# UNITED STATES PATENT AND TRADEMARK OFFICE

| APPLICATION NO. | FILING DATE | FIRST NAMED INVENTOR | ATTORNEY DOCKET NO. | CONFIRMATION NO. |
|-----------------|-------------|----------------------|---------------------|------------------|
| 10/018,596      | 03/14/2002  | Gerhard Rinninger    | 15028               | 8380             |

## Office Action Summary

Claims 22 and 23 are rejected under 35 U.S.C. 103(a) as being unpatentable over **Becker et al. (U.S. 5,275,541)** in view of **Becker (U.S. 3,947,156)**.

Fig. 1 of Becker et al. ('541)

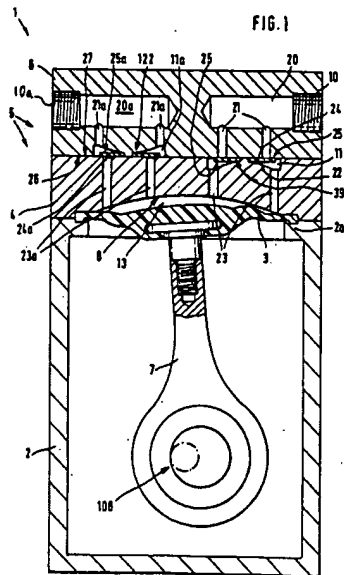
With respect to claim 19, **Becker et al.** teach a pump having a membrane M actuated by a crank drive, said membrane bounding in conjunction with a concave pump body surface BS, a pump chamber 13, an inlet channel 21, 23 and an outlet channel 24a, 23a which open to respectively an inlet opening and an outlet opening in the pump body surface, said membrane having a membrane core and an elastically deformable membrane ring MR, said membrane core having a convex surface, which is conformed to the pump body surface, said inlet opening being arranged in a region of the pump body surface which the membrane initially approaches during an expulsion stroke of the crank drive and wherein the elastically deformable membrane ring closes the inlet opening before the reaching of top dead center of the crank drive, and wherein an inlet valve 24 is provided which is arranged in the region of the inlet opening of the inlet channel, characterized in that in an edge region of the inlet opening, there is formed a surrounding control edge against which the elastically deformable membrane ring bears so as to close the inlet valve. See particularly **Figure 1**.

With respect to claim 21, **Becker et al.** teach that the middle point of the inlet opening is located at least approximately in the plane of rotation of the crank of the crank drive. See particularly **Figure 1**.

With respect to claim 24, **Becker et al.** teach that the middle axis of the inlet channel is orientated perpendicularly to the pump body surface. See particularly **Figure 1**.

With respect to claim 25, **Becker et al.** teach that the outlet opening of the outlet channel is arranged in a region of the pump body surface which is last approached by the membrane and which is reached earliest by the membrane at the top dead center of the crank drive. See particularly **Figure 1**.

With respect to claim 26, **Becker et al.** teach that the middle point of the outlet opening of the outlet channel is arranged in an inner region of the pump body surface 4 which is located opposite to the membrane core of the membrane 2. See particularly **Figure 1**.

On page 7 last paragraph of the response, applicant argues with regards to the reference Becker et al. ('541) "*the inlet and outlet channels extend directly into the pumping chamber without having an edge surrounding the region where the channels reach into the chamber as in the present invention*". Examiner disagrees because Becker ('541) does teach that the inlet and outlet channels have an edge (area surrounding opening) surrounding the region where the

channels reach into the chamber as in the present invention. See **Figure 1** of Becker et al. ('541).

On page 8 first paragraph of the response, applicant argues with regards to the reference Becker et al. ('541) "*the valves are not closed by the diaphragm*". Examiner disagrees because Becker ('541) does teach that the inlet valves are closed when the diaphragm performs a compression stroke and the outlet valves are closed when the diaphragm performs a suction stroke. See **Figure 1** of Becker et al. ('541).

Figs. 1 and 3 of Becker ('156)

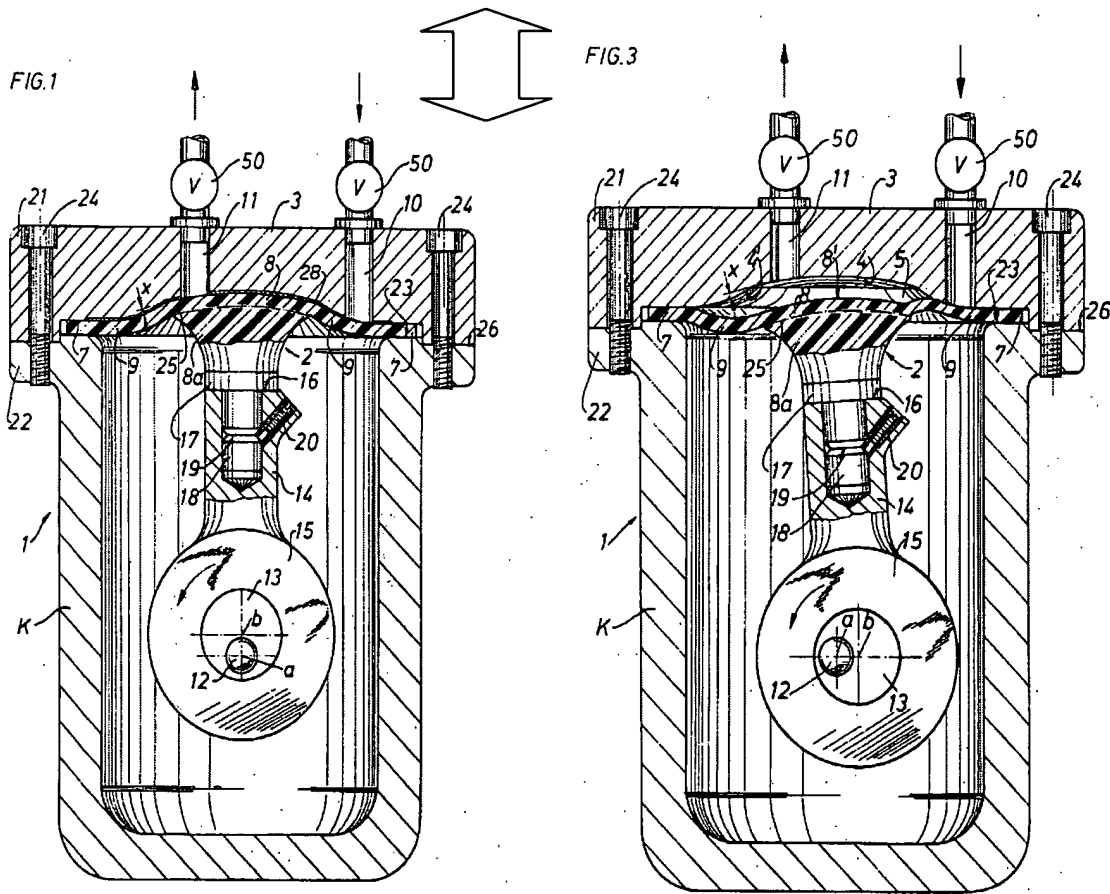
With respect to claims 22 and 23, **Becker et al. ('541)** do not schematically show that the elastically deformable membrane ring closes the inlet opening at a rotary cranking position of the crank drive which is at an angle of up to 90 degrees or within the range of about 20 degrees to 90 degrees before top dead center. However, Becker ('156) teaches a similar apparatus to Becker et al. ('541). Further, Figures 1 and 3 of Becker ('156) teach that it is obvious if not inherent that the that the elastically deformable membrane ring closes the inlet opening at a rotary cranking position of the crank drive which is at an angle of up to 90 degrees or within the range of about 20 degrees to 90 degrees before top dead center. Notice that **Figure 1** is the TDC position while **Figure 3** is 90 degrees before TDC. To see this, refer to the location of the axes **a** and **b** corresponding to elements 12 and 13 respectively. As you can see from **Figure 3**, axis **a** and **b** are 90 degrees before TDC. See particularly **Figures 1, 3 of Becker; Figure 1 of Becker et al.** and compare the location of elements **a** and **b**.
